SUBJECT: Transmittal of Revised Responses to AP1000 DSER Open Items

AP1000 Design Certification Review
Draft Safety Evaluation Report Open Item Non-Proprietary Responses

DSER Open Item Number: 3.8.2.1-1 Revision 2

DSER Open Item Number: 19.1.10.1-5 (Response Revision 2)

Figure A5.3-1

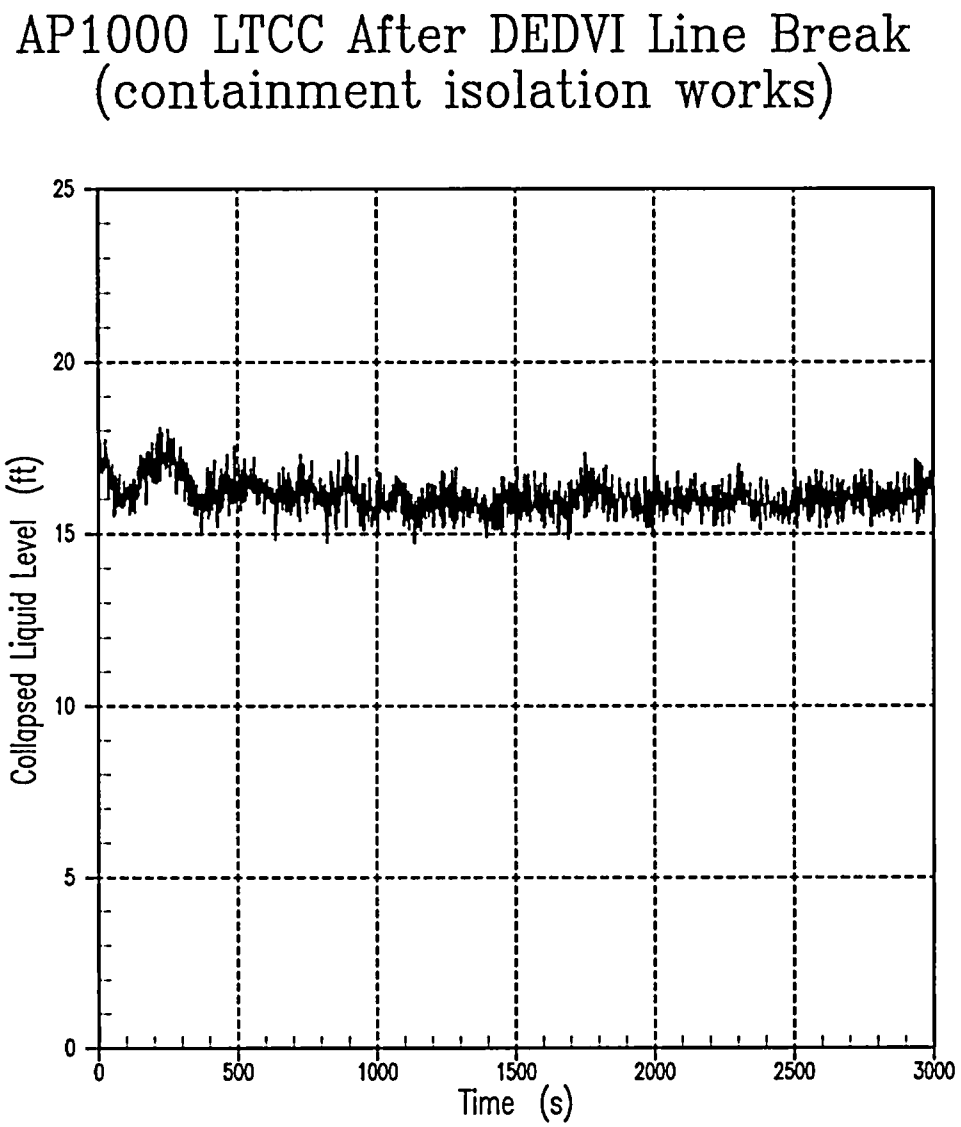
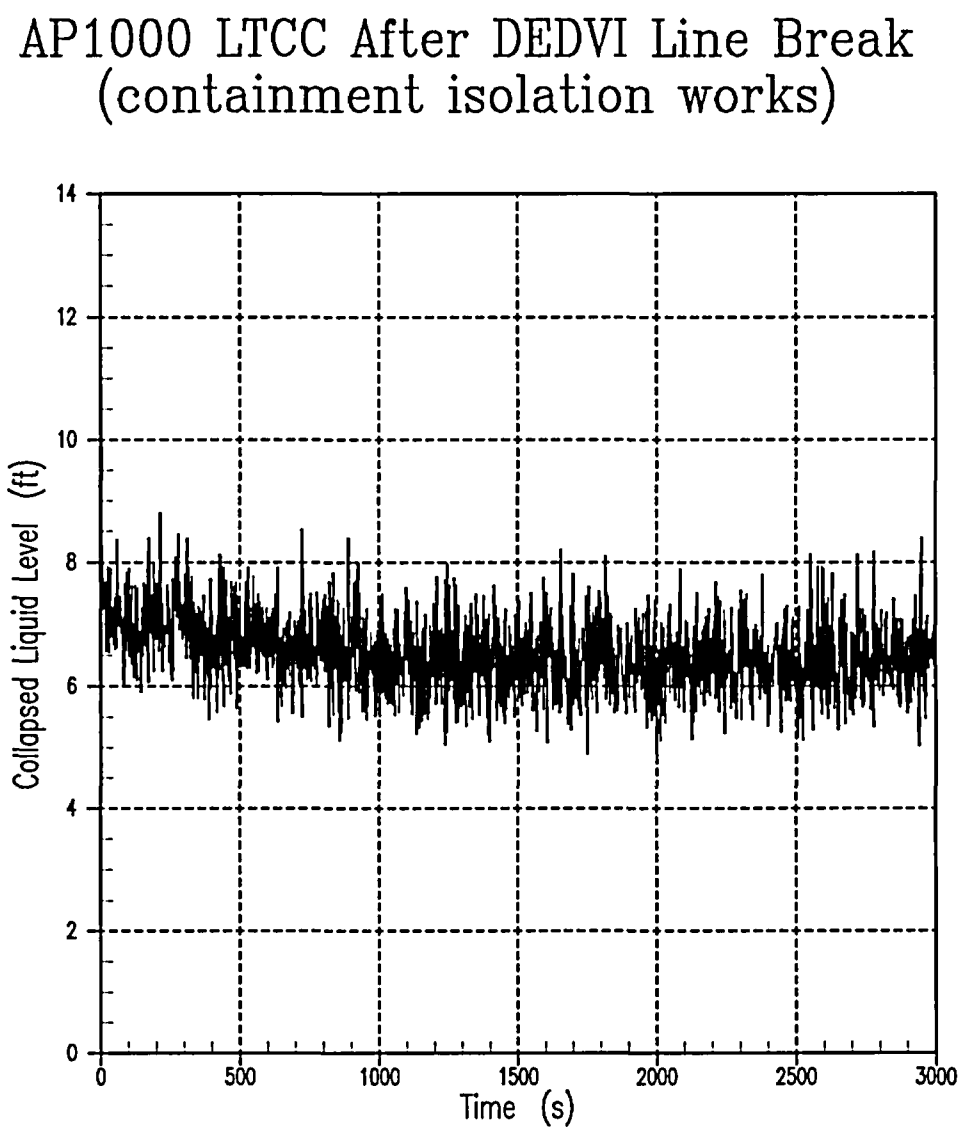
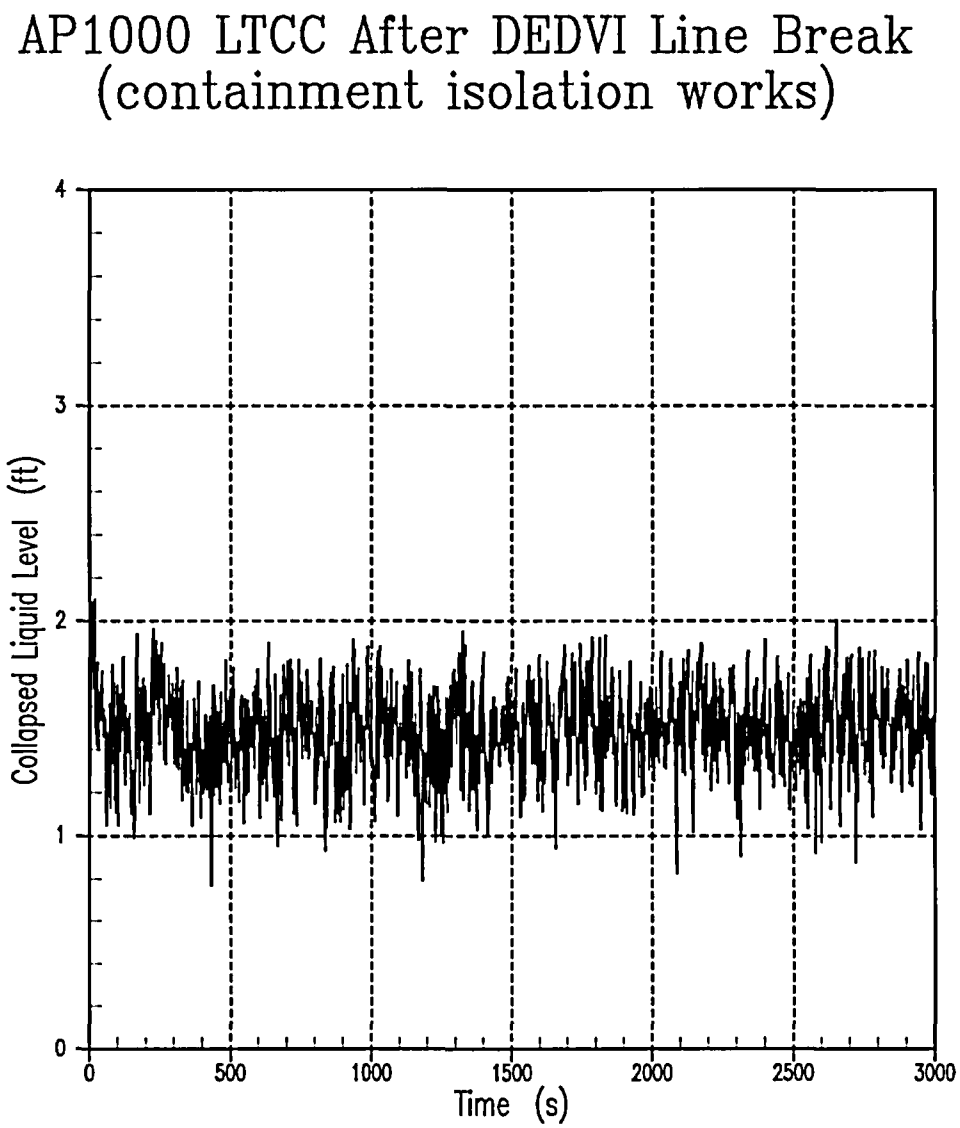
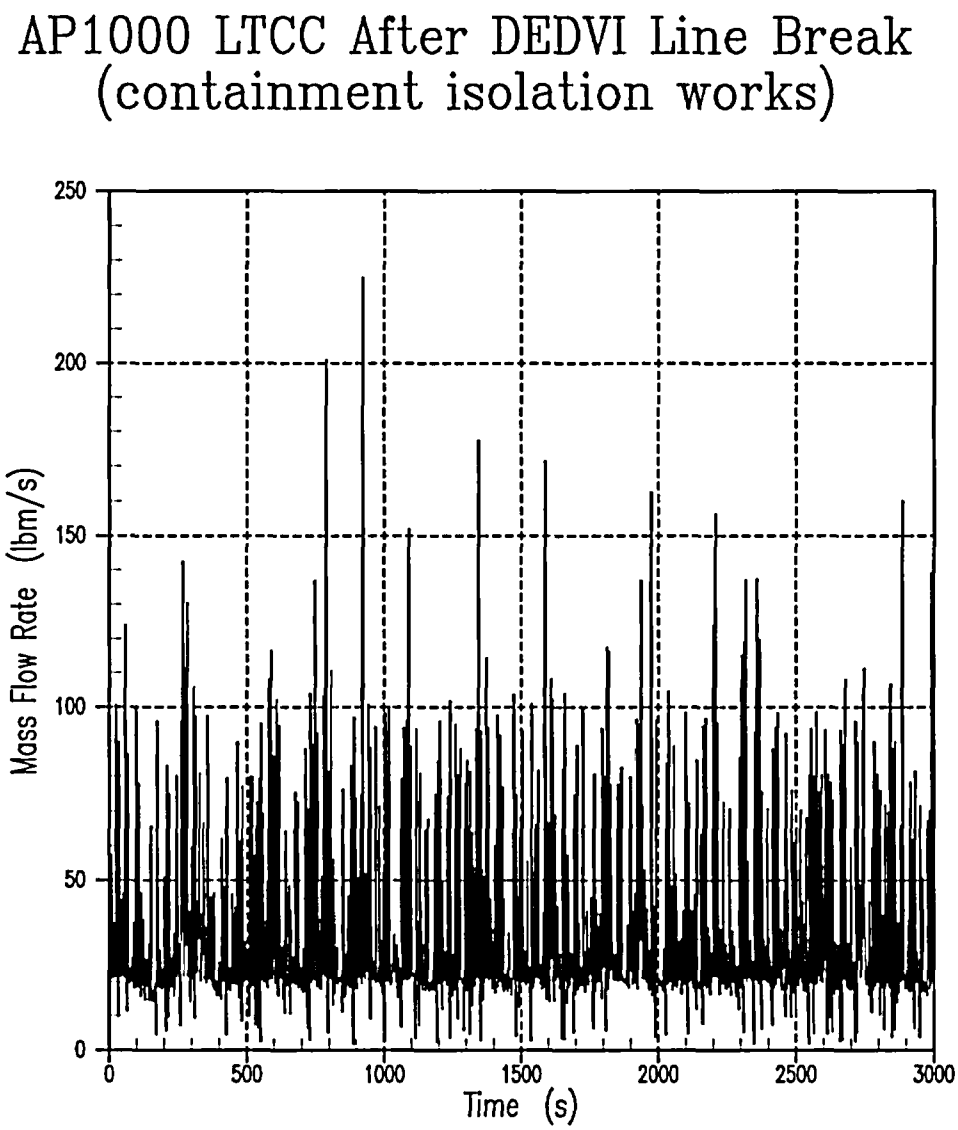
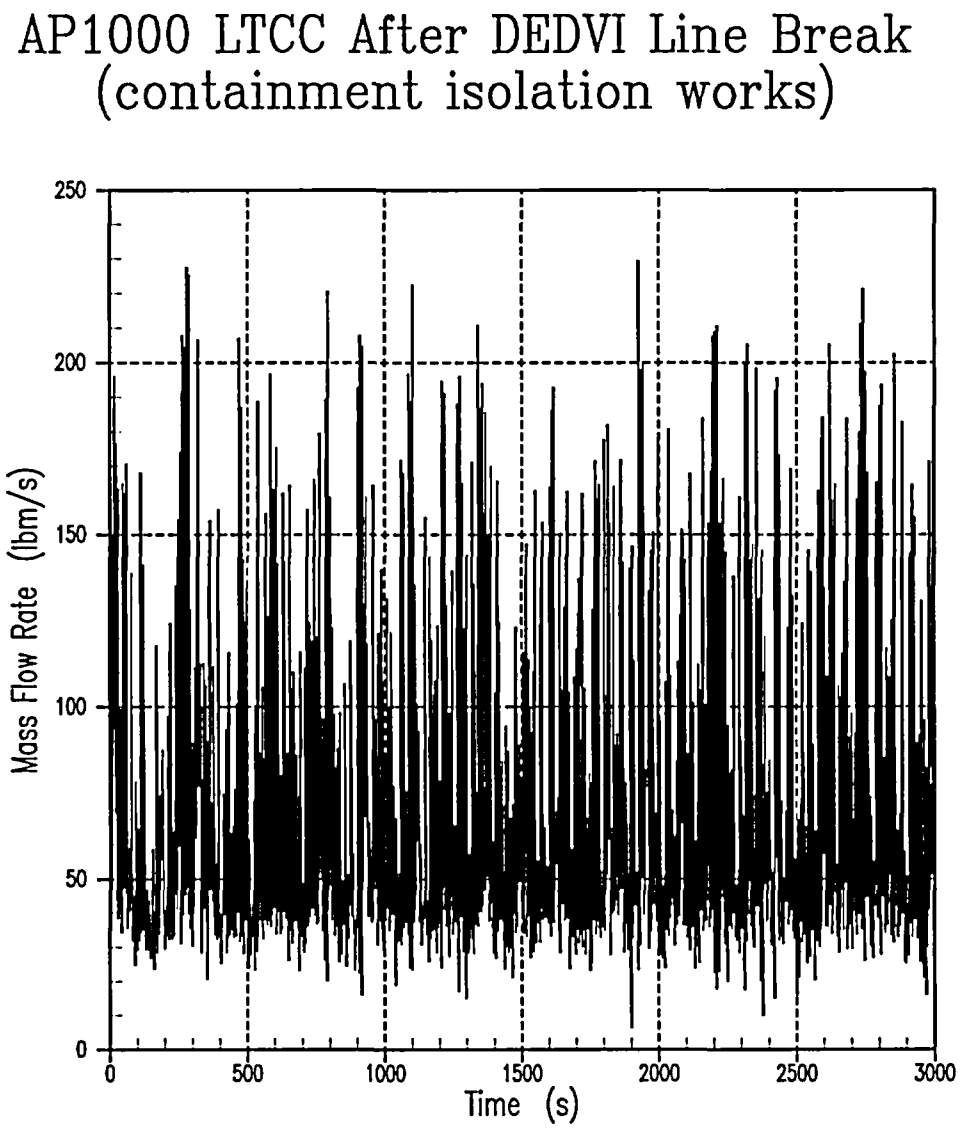
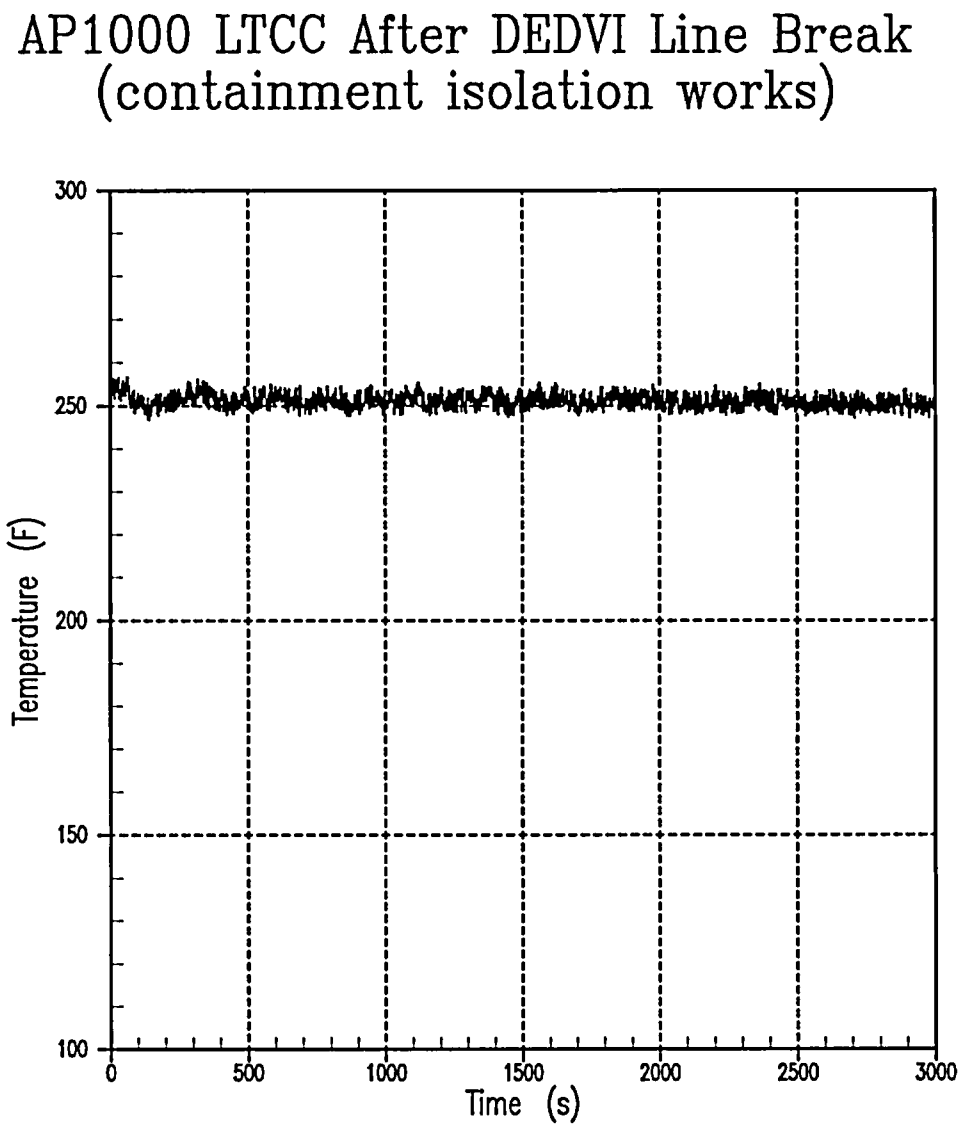
This issue remains open. In the revised response to RAI 720.013, Westinghouse performed long term cooling analyses for bounding conditions in the PRA. (Case F DEDVI, 1 CMT, 1 recirc line, 3/4 ADS4 and CI) and (Case G DEDVI, 1 CMT, 1 recirc line, 4/4 ADS4 and CI failure). The WCOBRA/TRAC code was used for LTC calculations with input conditions derived from MAAP4 analyses. As discussed in the DSER the staff has not reviewed MAAP4 except for its use in screening studies. These are analyses using minimum equipment sets as discussed in the DSER. The staff believes that only a methodology the staff has reviewed should be utilized. In addition, as a result of staff and ACRS questions, the WCOBRA/TRAC long term cooling model has been changed. The staff believes that the revised model should be used in these bounding calculations.

(a) The long term cooling success criteria analysis case and the thermal hydraulic uncertainity cases F and G have now been performed using the revised WCOBRA/TRAC model and using input conditions from WGOTHIC. The revised cases replace the previous cases as shown below in the revision to PRA Appendix A.

~~momentarily, faster depressurization occurs at about 2.05 hours into the transient (Figure A5.3-11). Consequently, the IRWST injection is increased even further, and as a result, the~~ The levels in the downcomer (Figure A5.3-1), the reactor core (Figure A5.3-2), and the upper plenum (Figure A5.3-8) are ~~also increased. The effect of this injection flow increase can also be seen on Figure A5.3-4, which shows a sharp void fraction decrease in the upper half of the fuel region~~adequate to maintain acceptable core cooling.

The available three out of four ADS Stage 4 valves provide enough venting capacity to assure adequate depressurization and successful performance of the passive safety systems (Figures A5.3-9 and A5.3-10). The fuel remains covered throughout the transient and adequate core cooling is provided to remove the decay heat. The hot rod cladding temperature at the top of the core is about 20°F above saturation (Figure A5.3-12) and ~~is steadily decreasing~~exhibits no excursions.
